PRODUIT: SURFACEUSES
GMA/GMP 1300 - GP 1000
PRODUCT: SURFACE GRINDERS

OBJET: SERRAGE DES SEGMENTS DE MEULE
SUBJECT: CLAMPING OF THE GRINDING
SEGMENTS

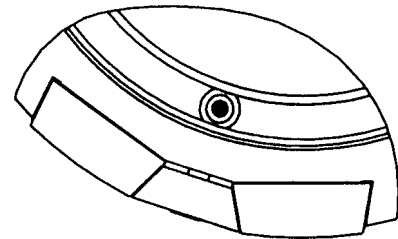
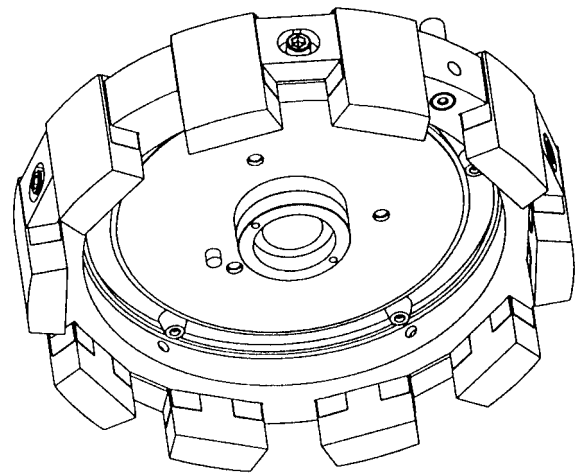
Because of the variance in the grinding segments width, smaller segments might not be clamped properly onto the segment holder / grinding wheel.

We noticed on few cases that the wedged clamp holding the segment might contact the grinding wheel before the grinding segment gets securely fastened.

SERDI recommends to replace the wedged clamps on all surface grinders in operation. A free of charge replacement kit is available.

The tightening screws remain the same.

Make sure to double check the balance of the grinding wheel after reassembly, and adjust the balancing counterweights accordingly.

Kit reference : **013126** including:
5 wedged clamps **013249.**
5 star washers **012762.**
